Seabrook Station

Procedure ER 5.4, Revision 35

Enclosure 1 to SBK-L-16037
Summary of Changes

ER 5.4, Protective Action Recommendations, Revision 35

Figure 1
Site Area Emergency Protective Action Flowchart

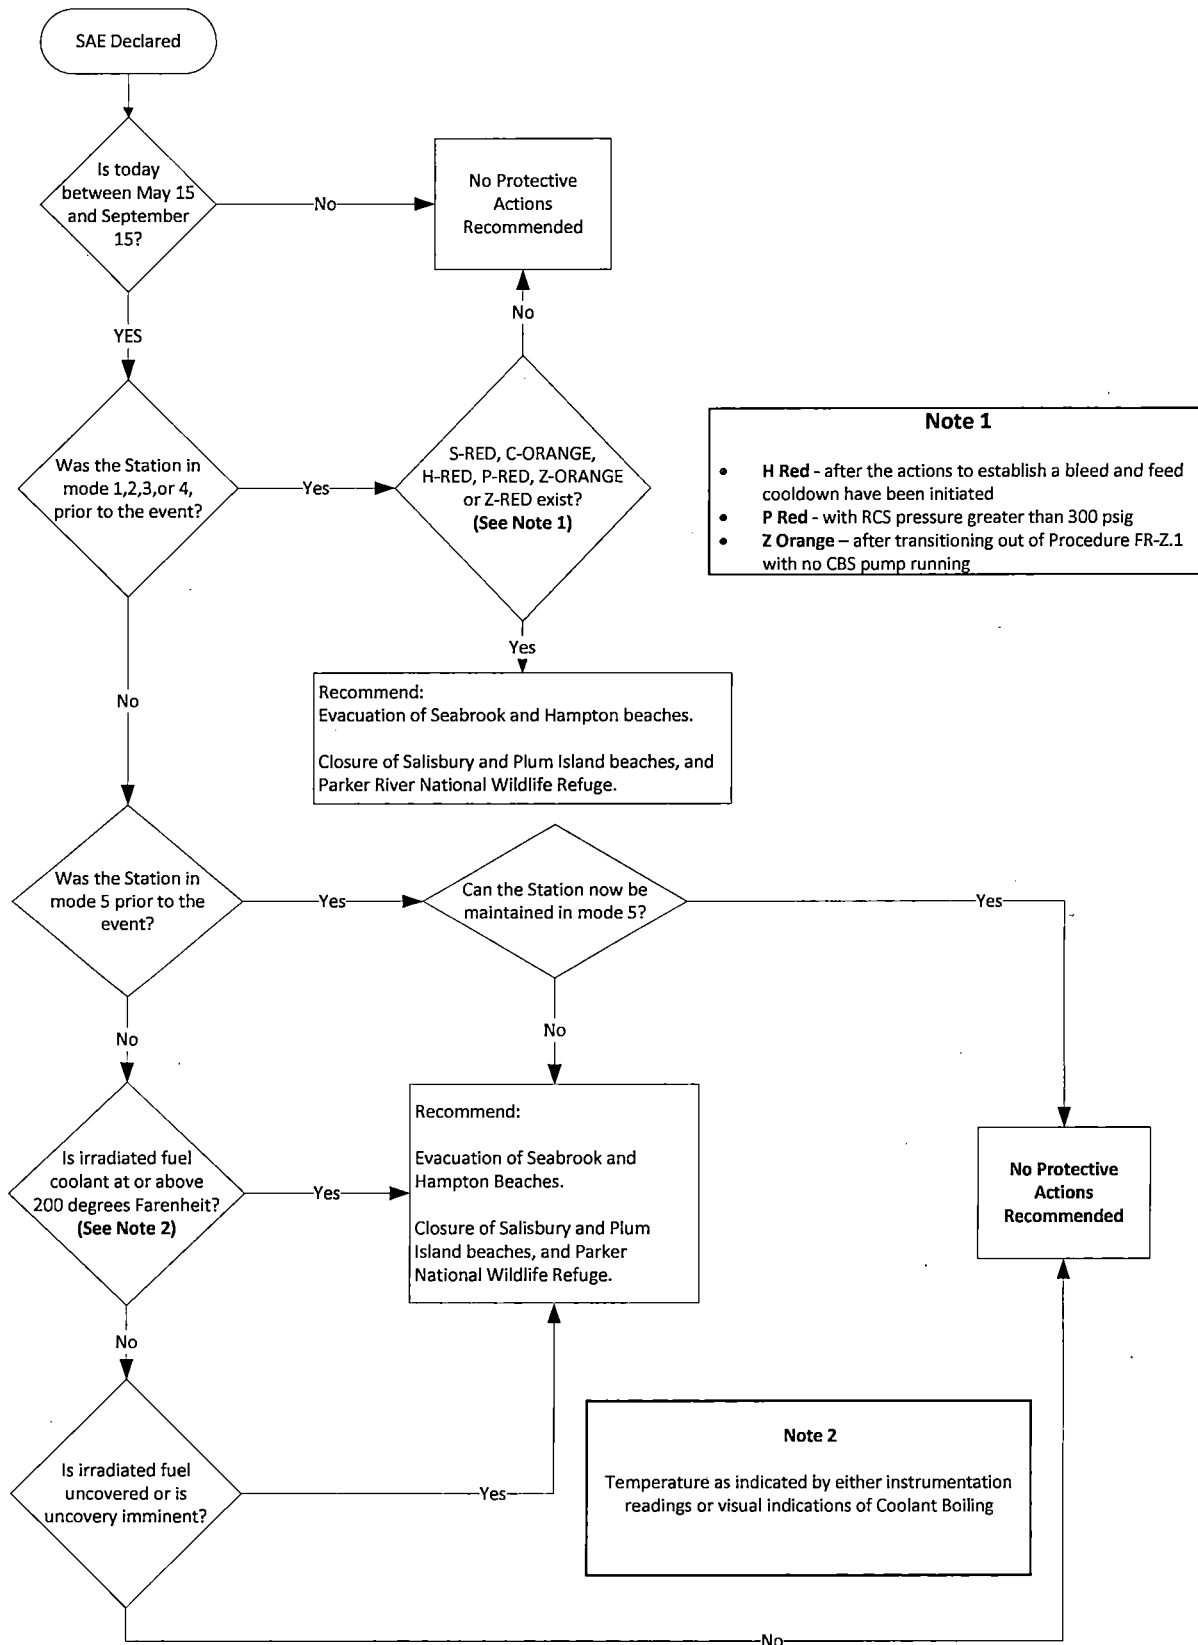
Consolidated Figure 1, Site Area Emergency Protective Action Flowchart into one page.

Figure 2
General Emergency Protective Action Flowchart

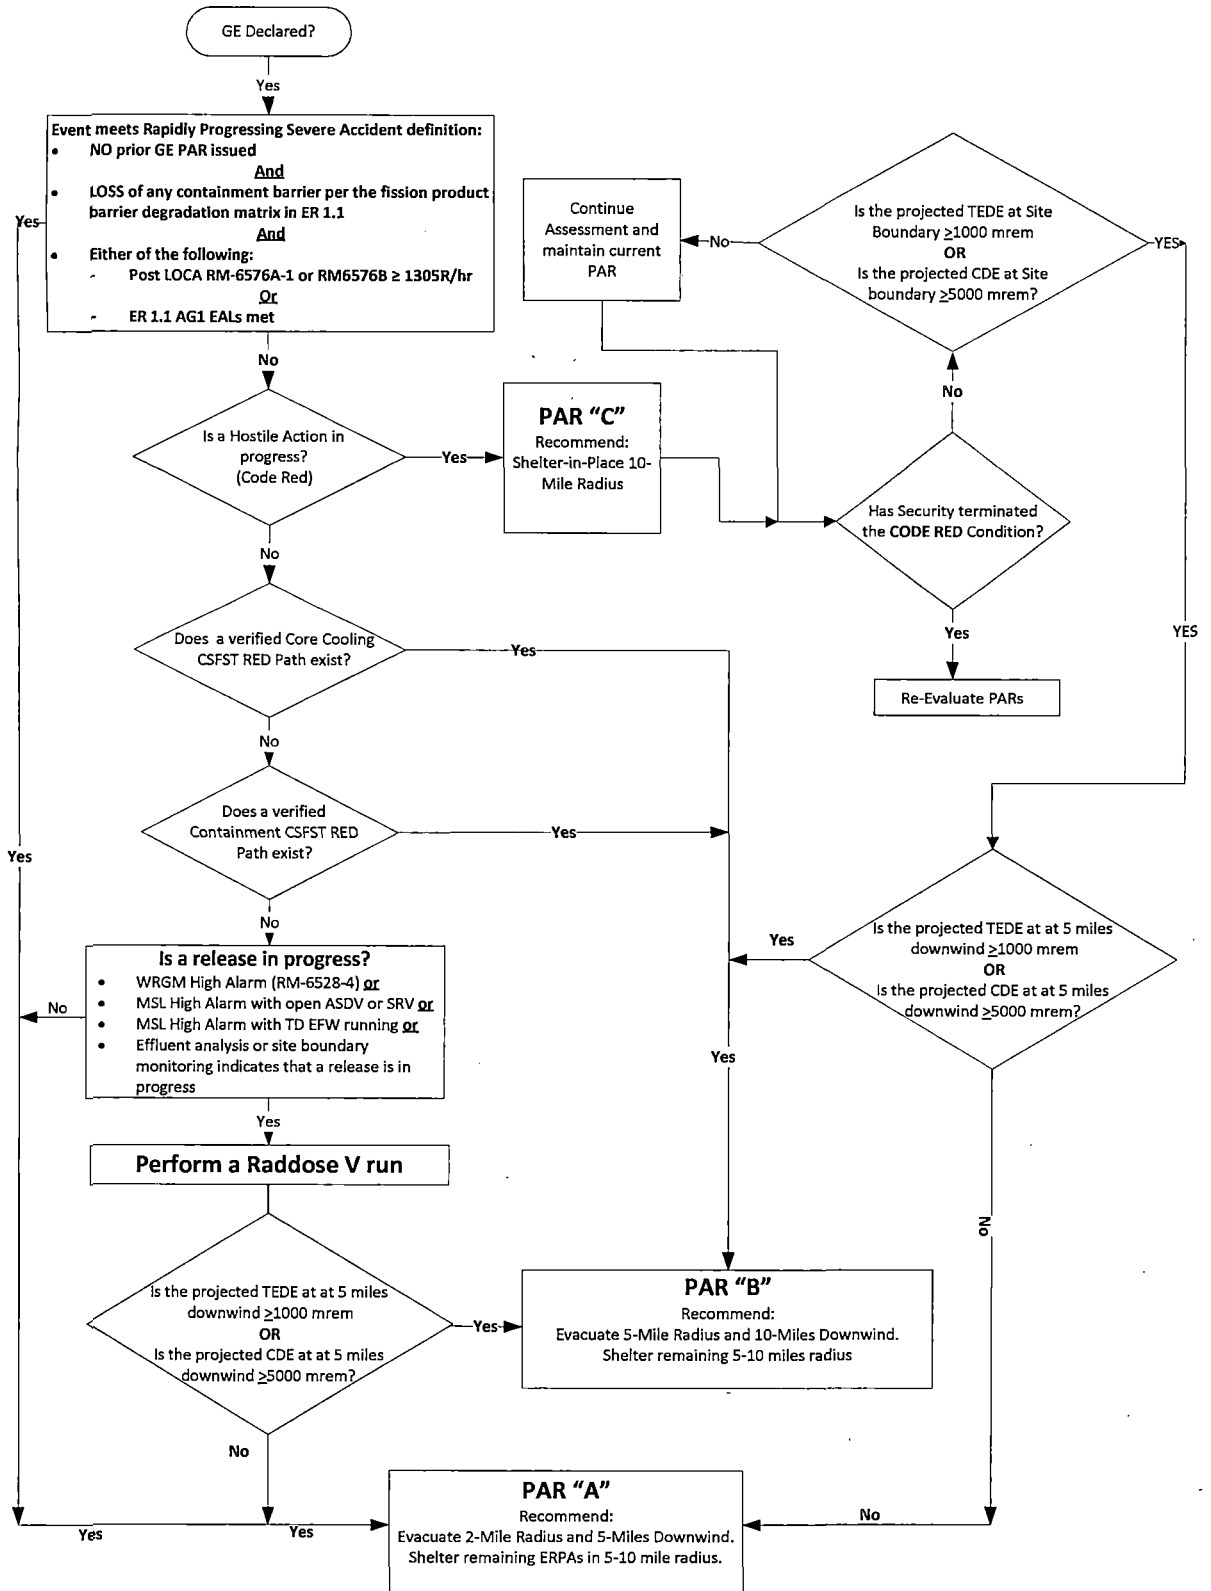
Added a new Figure 2, General Emergency Protective Action Flowchart to reflect NUREG-0654 Supplement 3 PAR Strategy guidance.
